Re: Second Submission Review: Parklands Village 1 Phase 2 – Site Plan and Plat
Application Number: DA-2289-06
Case Numbers: 2024-4015-00; 2024-3028-00

PARKLANDS VILLAGE 1 SITE PLAN NO. 2

PARKLANDS VILLAGE 1 SUBDIVISION FILING NO. 2

DETAIL #3
TWO-FAMILY (DUPLEX), ALLEY-LOADED GREENCOURT LOT
TYPICAL LOT UTILITY DETAIL
1" = 20'

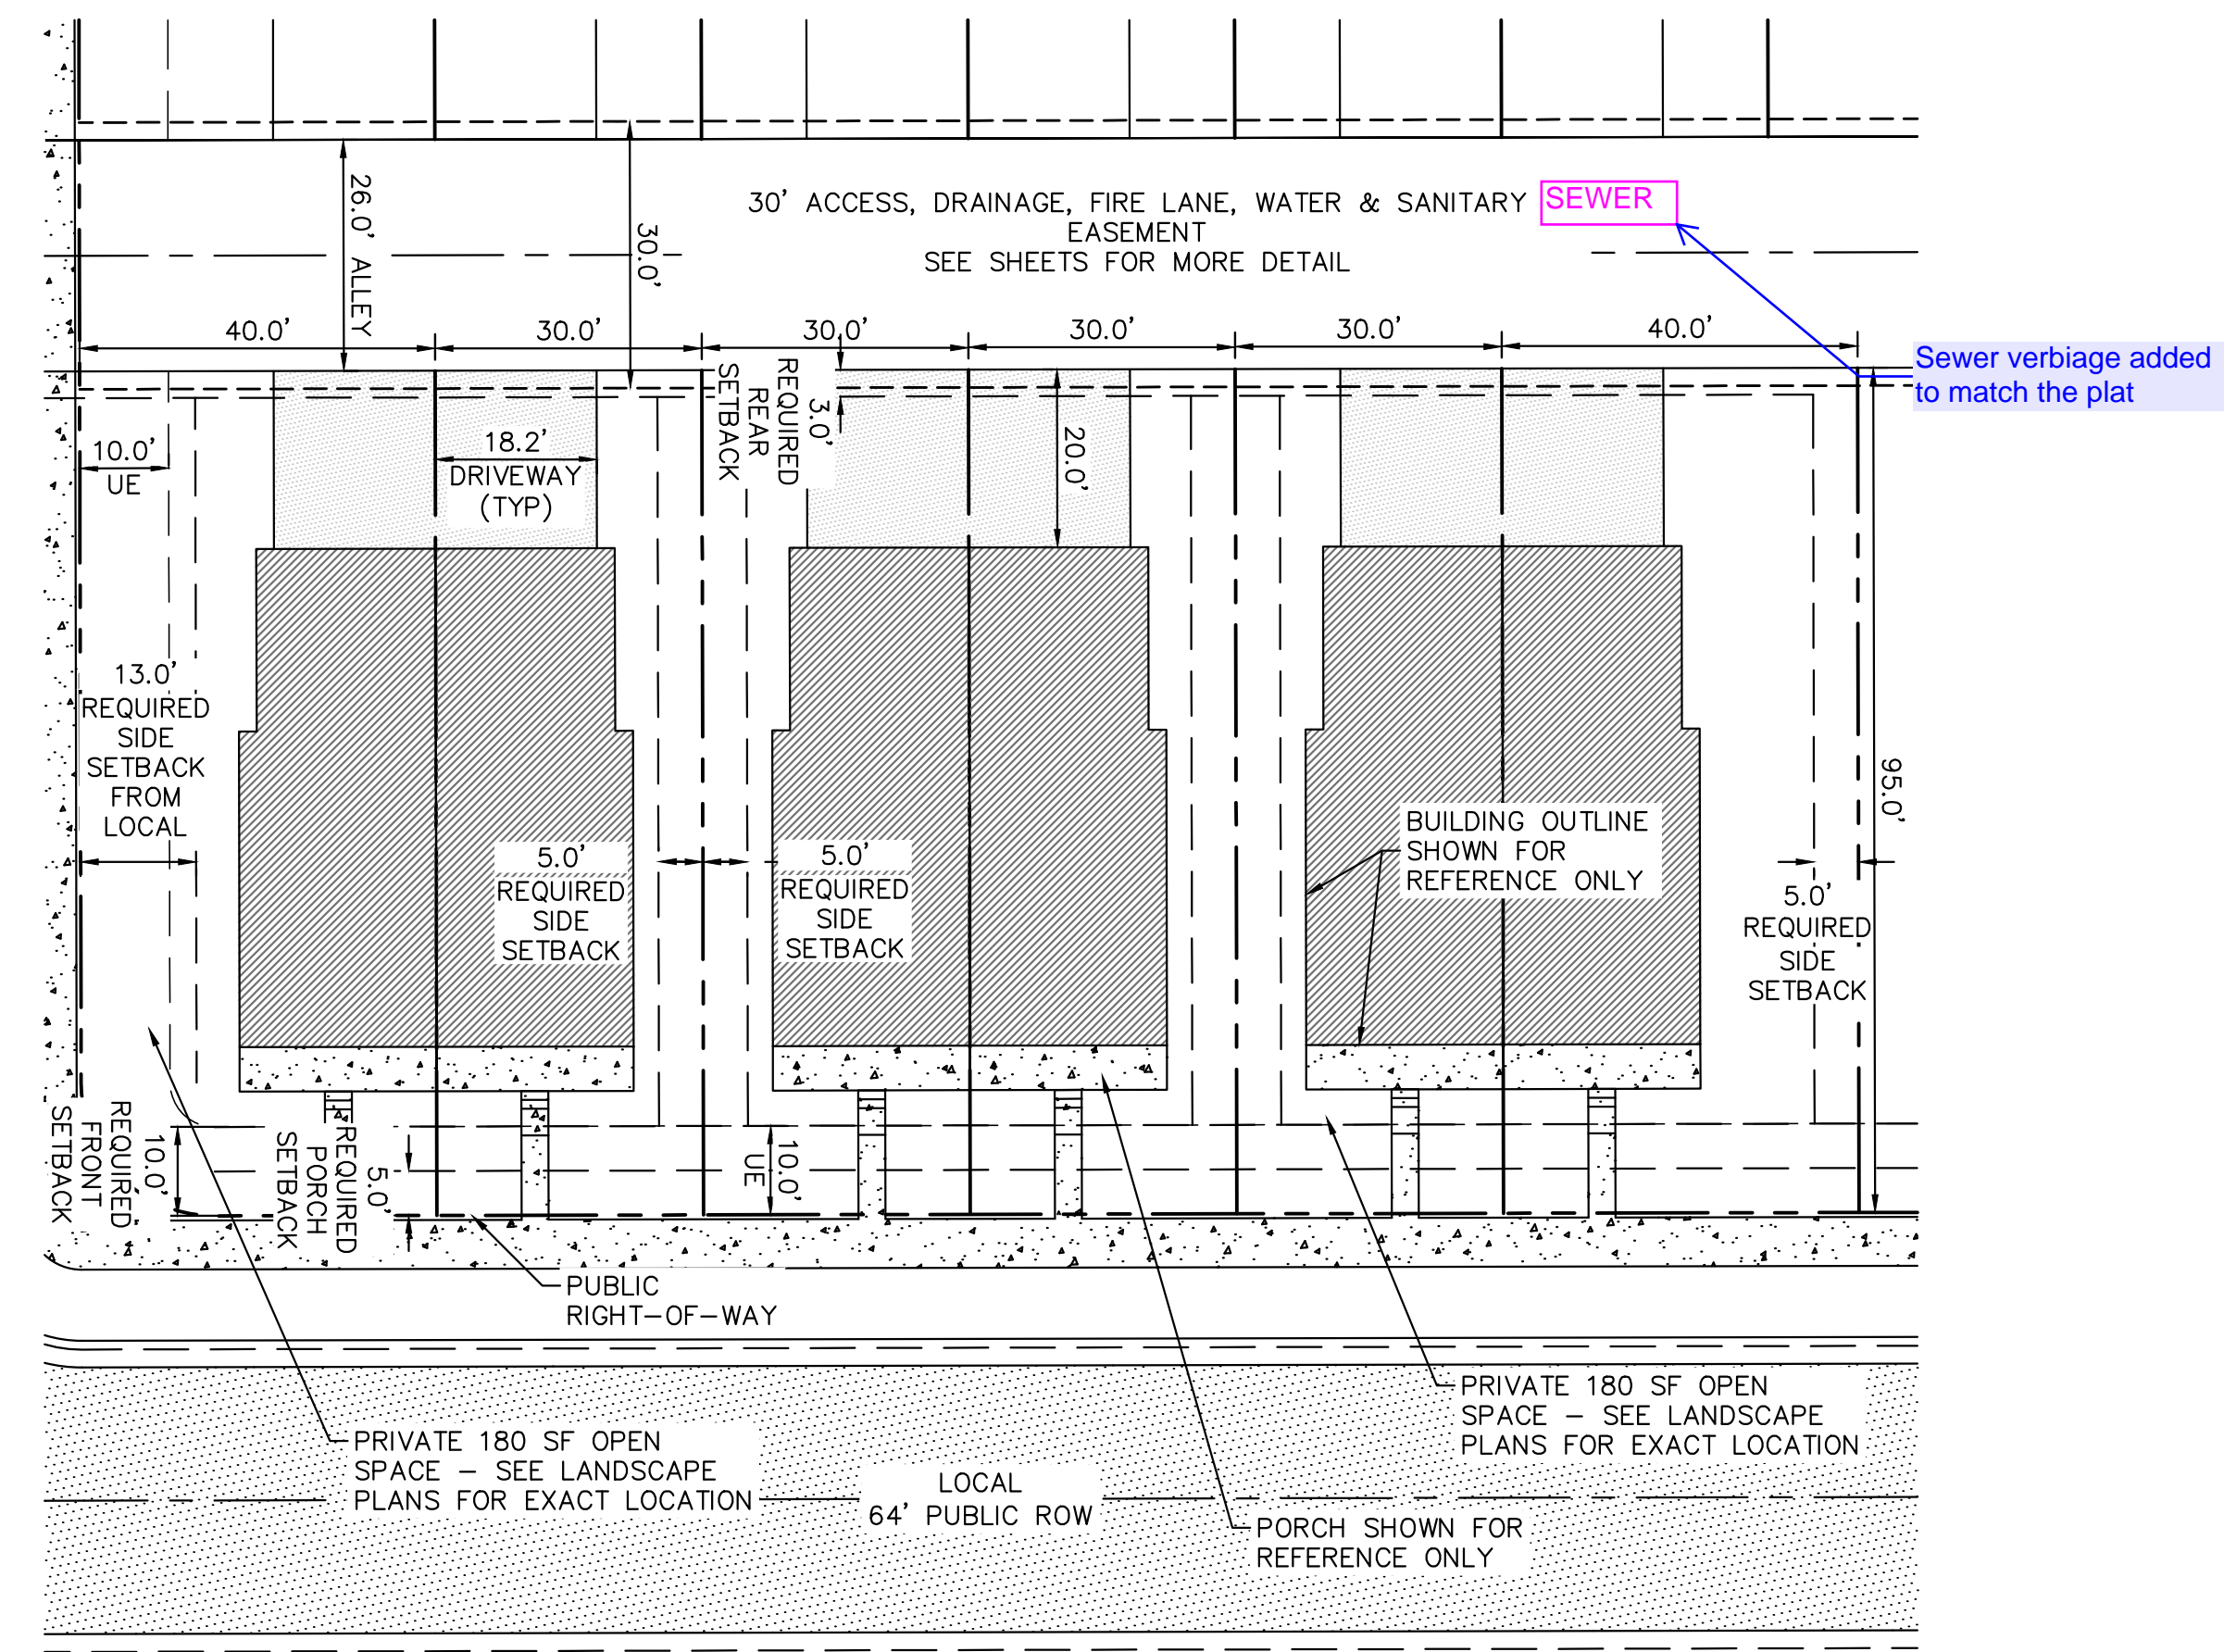
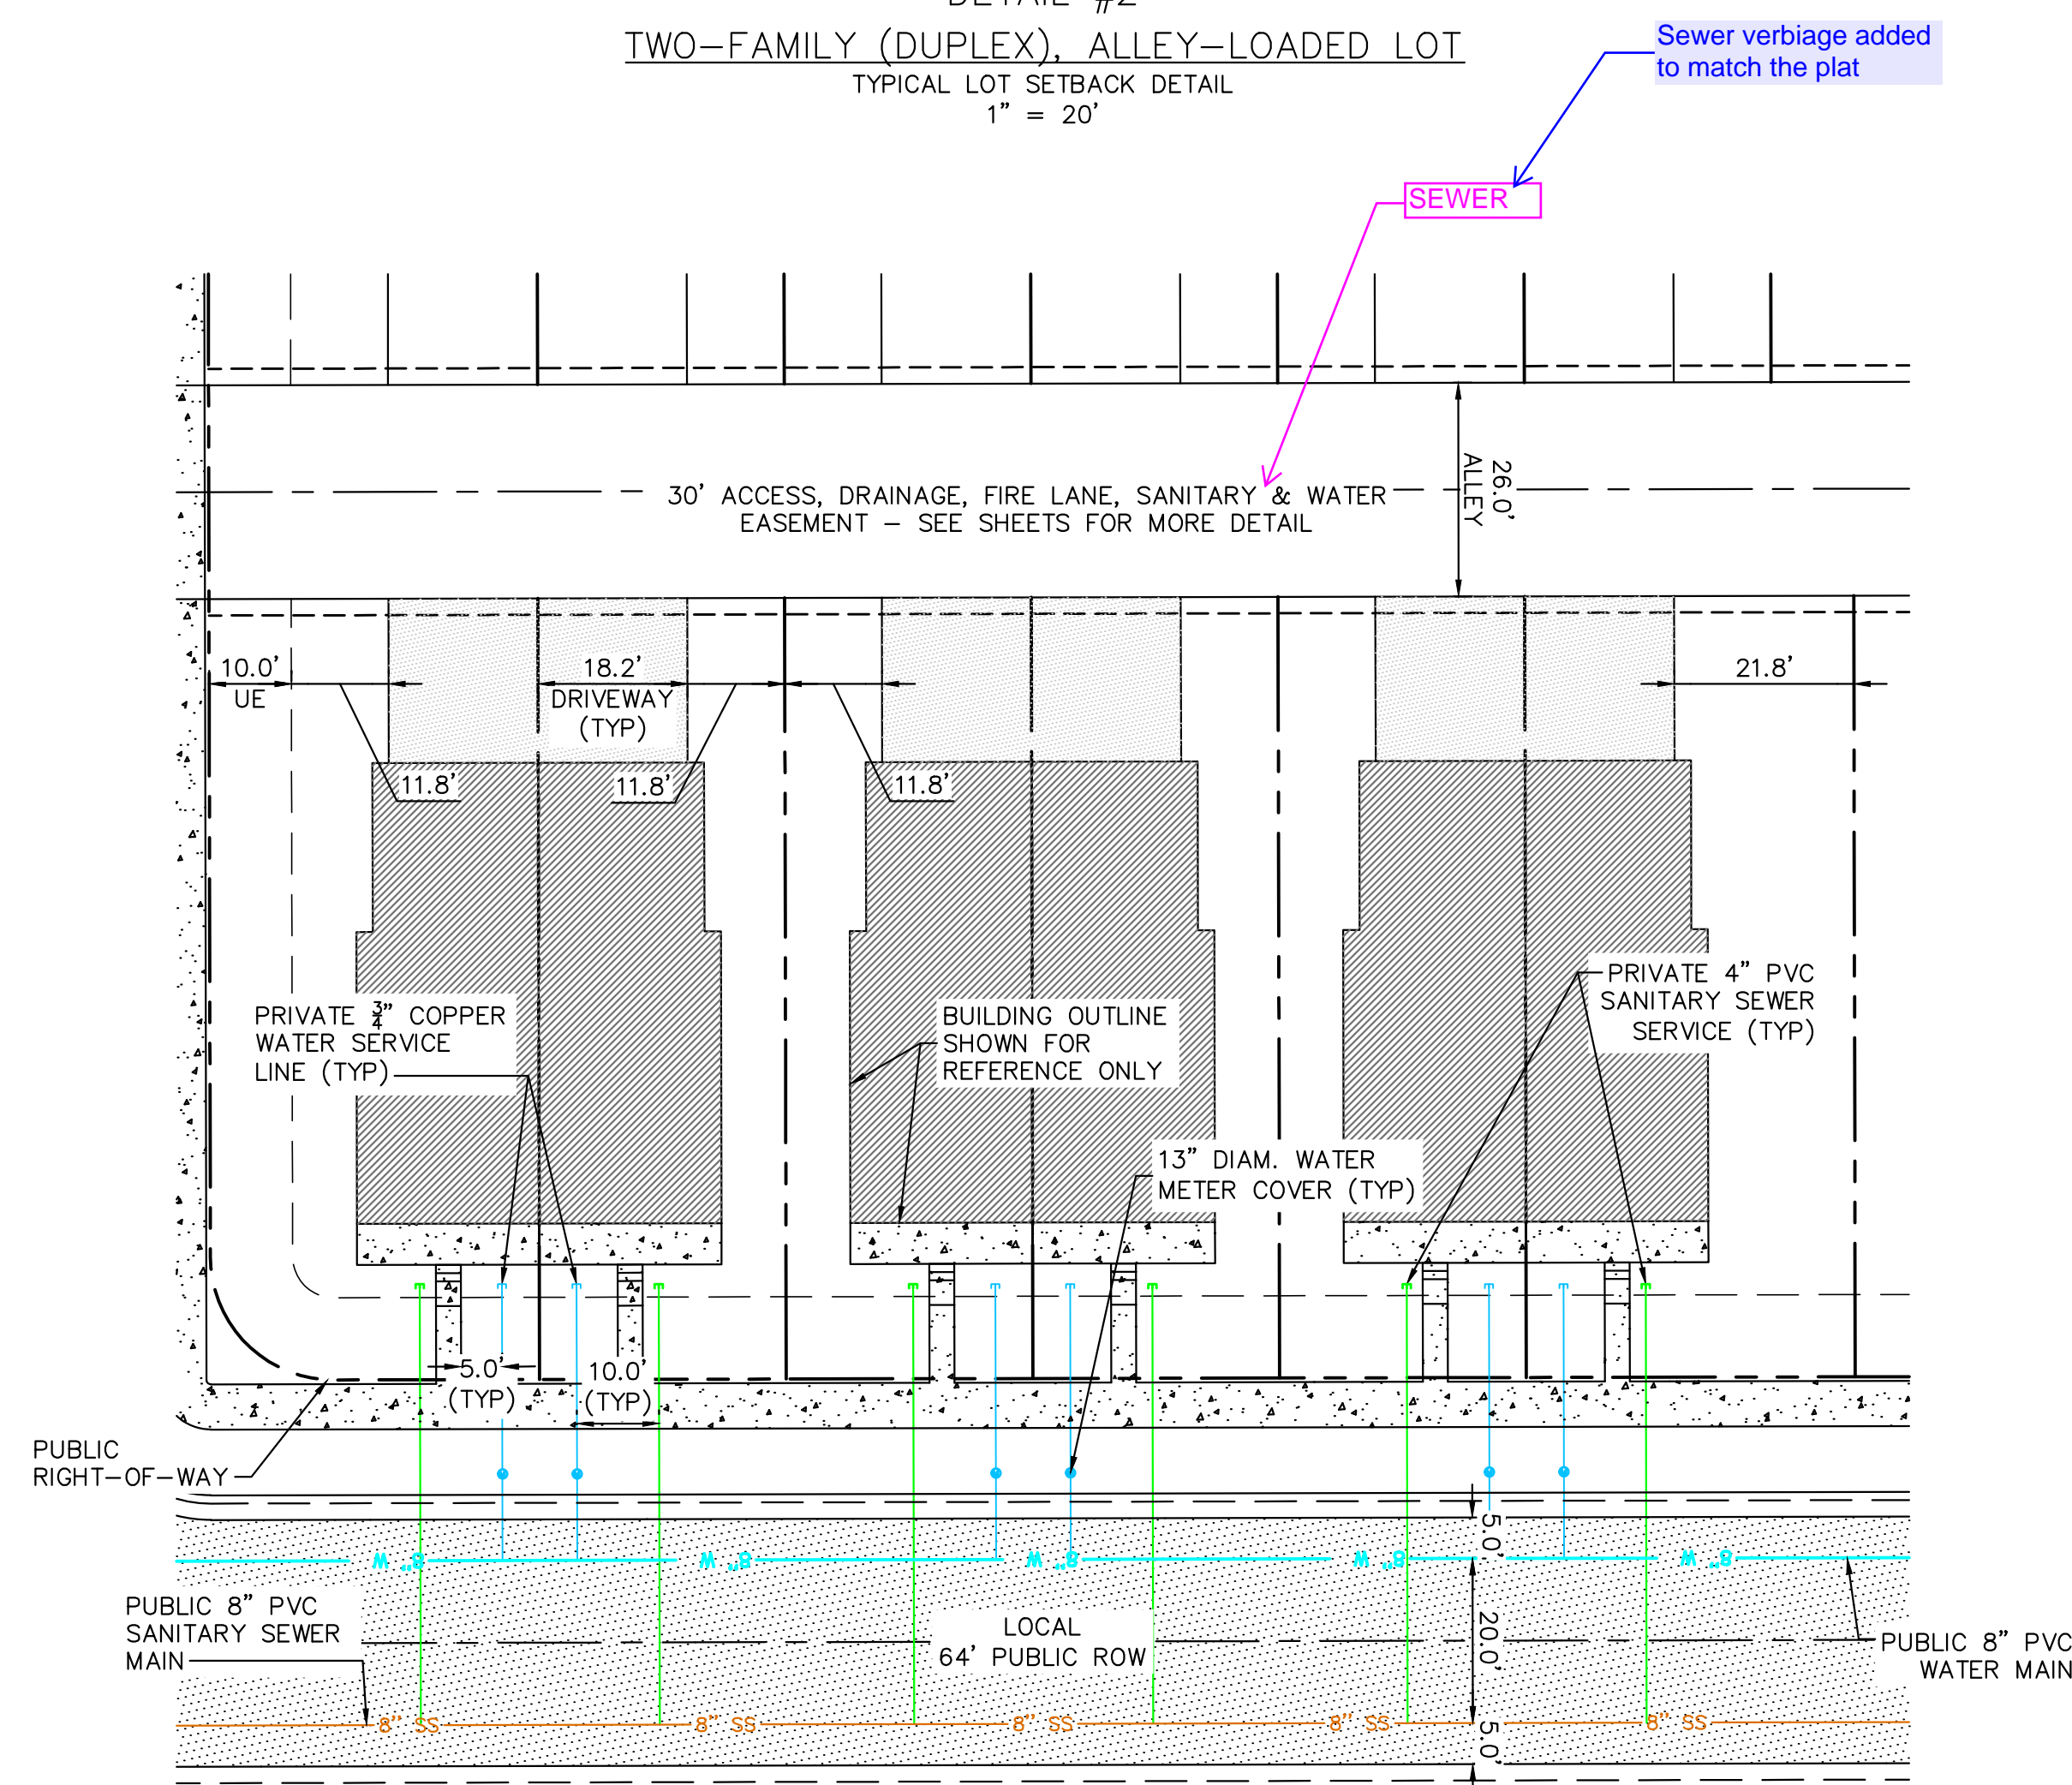
- These water easements for meters are not shown on the plat. They are also not shown in this site plan set on any utility page. Please update.

Easement label added to align with plat

THE PARKLANDS
VILLAGE 1 - SITE PLAN NO. 2
SITE PLAN

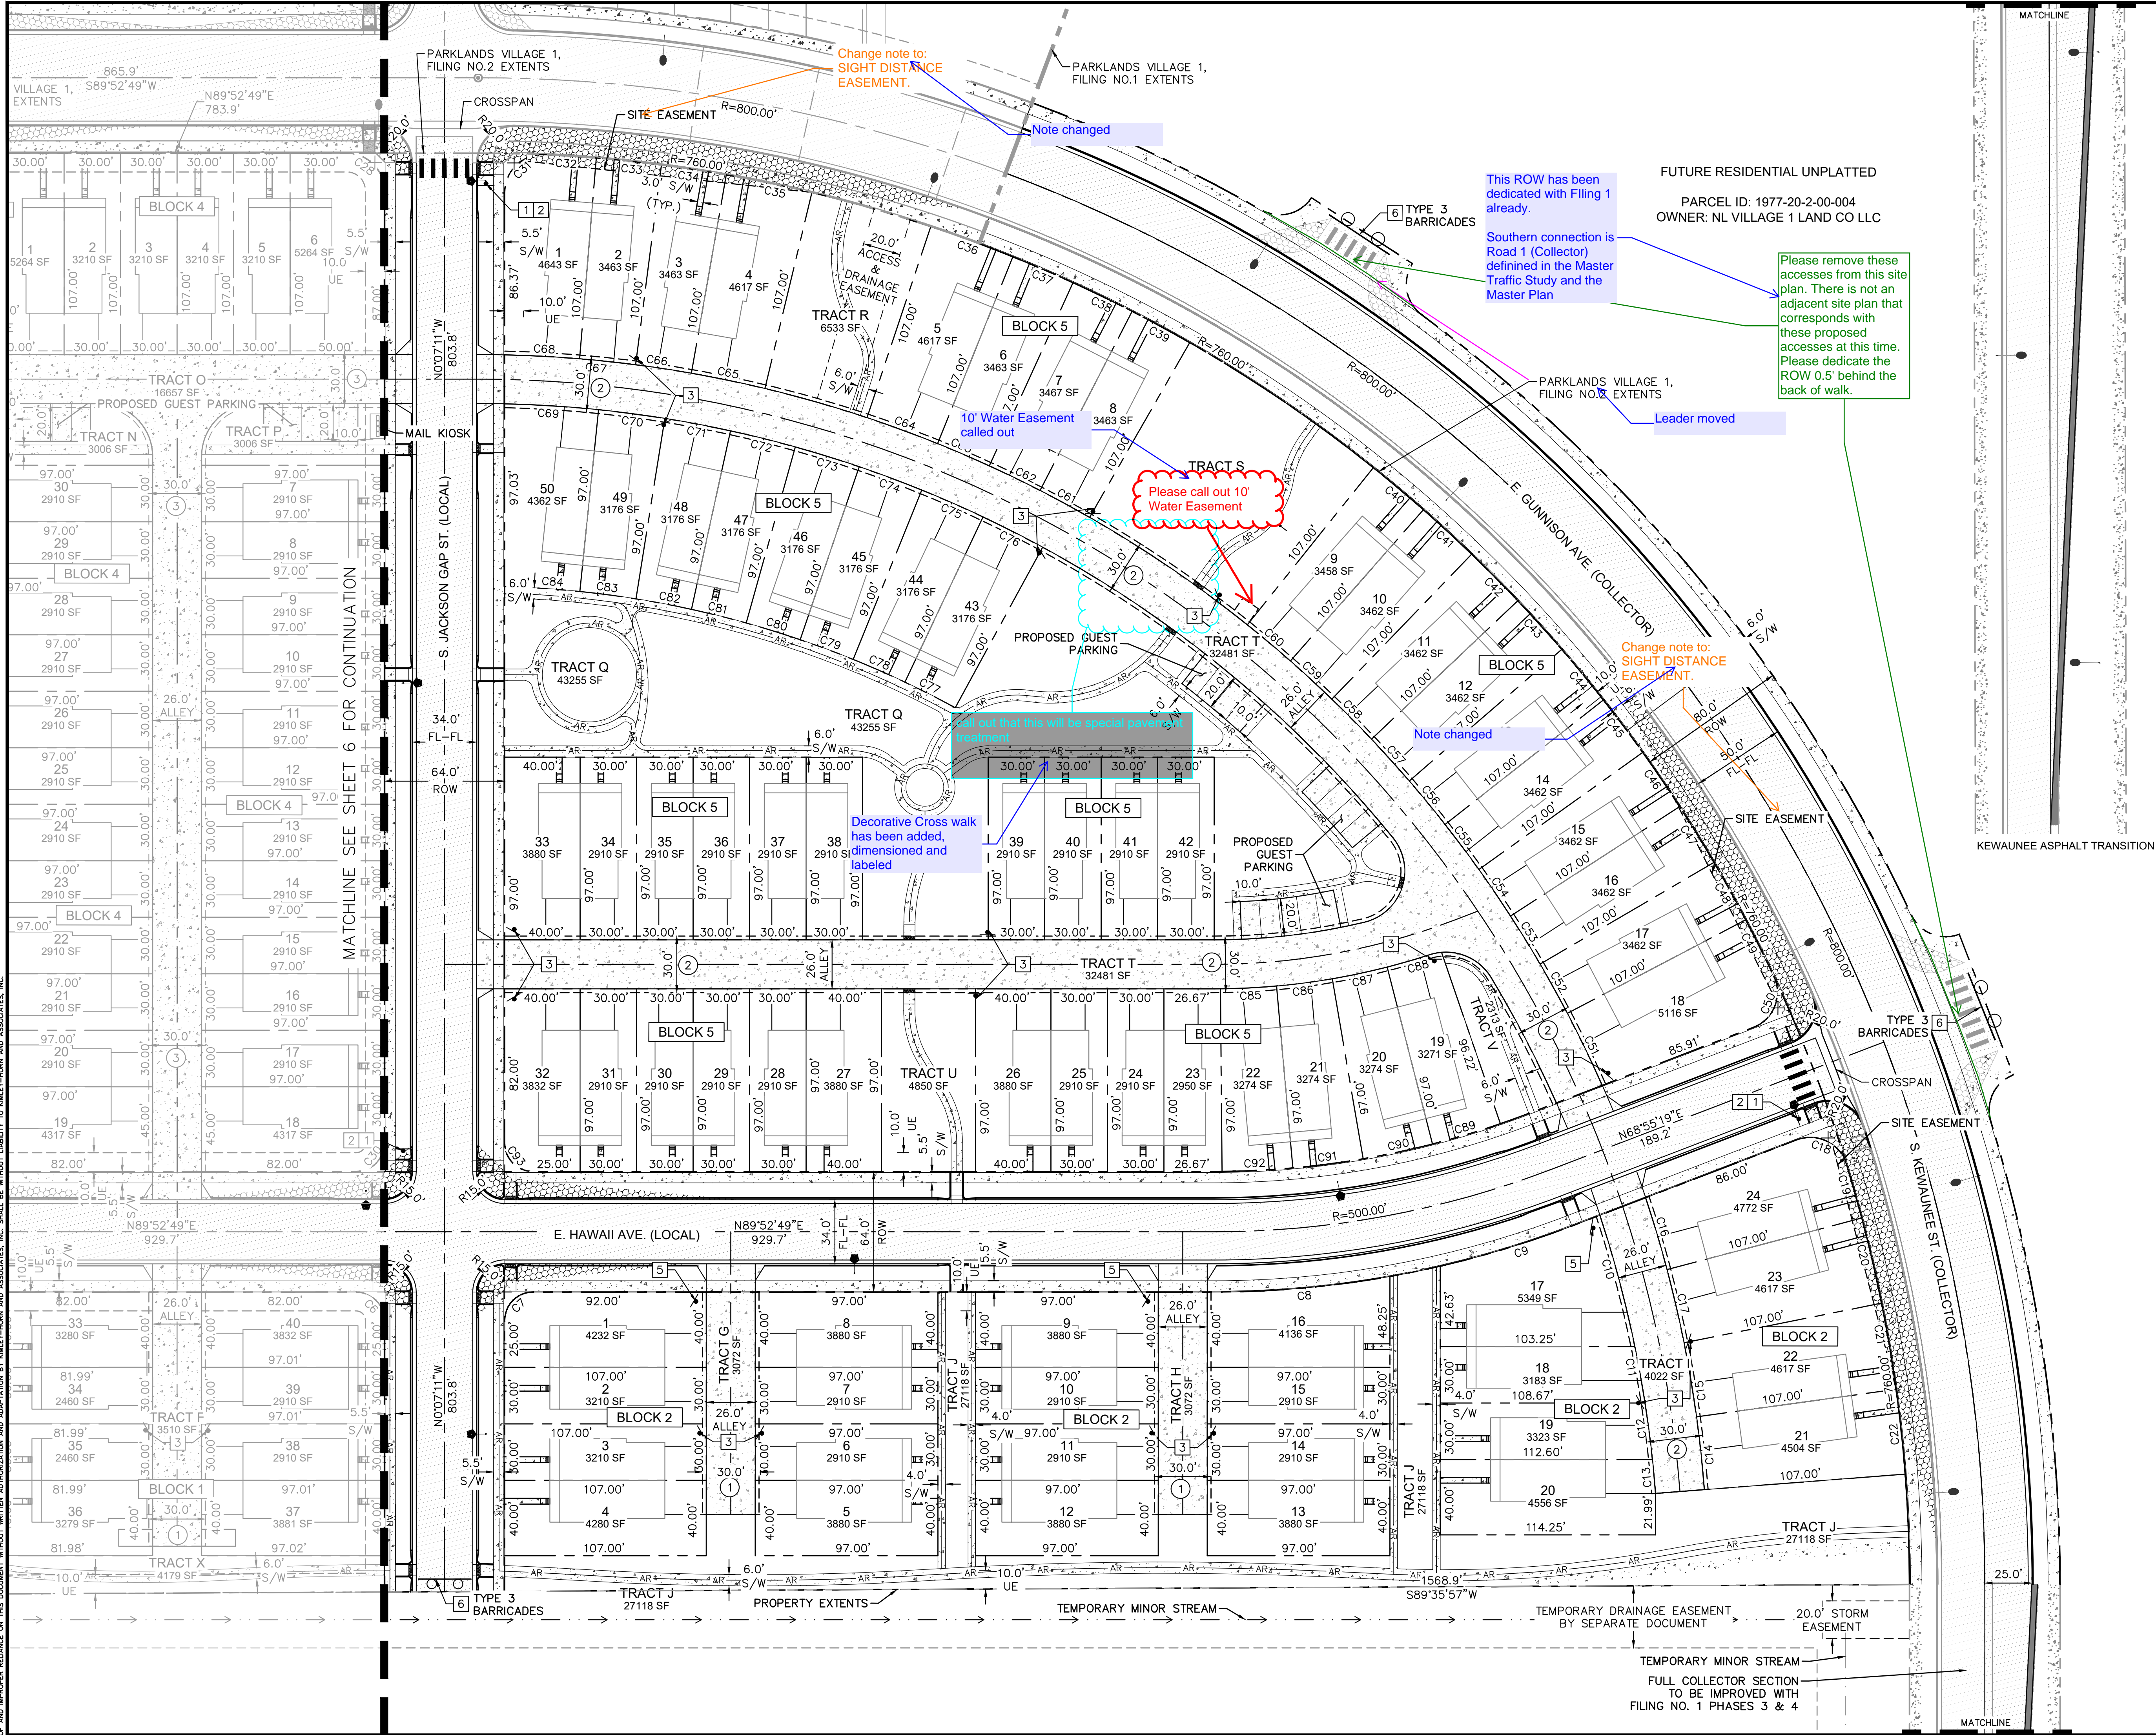
- Call out that the alley connecting the green court will require some special pavement treatment. This is also reflected on Sheet 16 of the landscape plan but should be more explicit.

① 30.0' FIRE LANE, ACCESS, SANITARY & WATER EASEMENT.

② 30.0' FIRE LANE, DRAINAGE, ACCESS, SANITARY & WATER EASEMENT.

③ 30.0' Sewer added SANITARY & WATER EASEMENT.
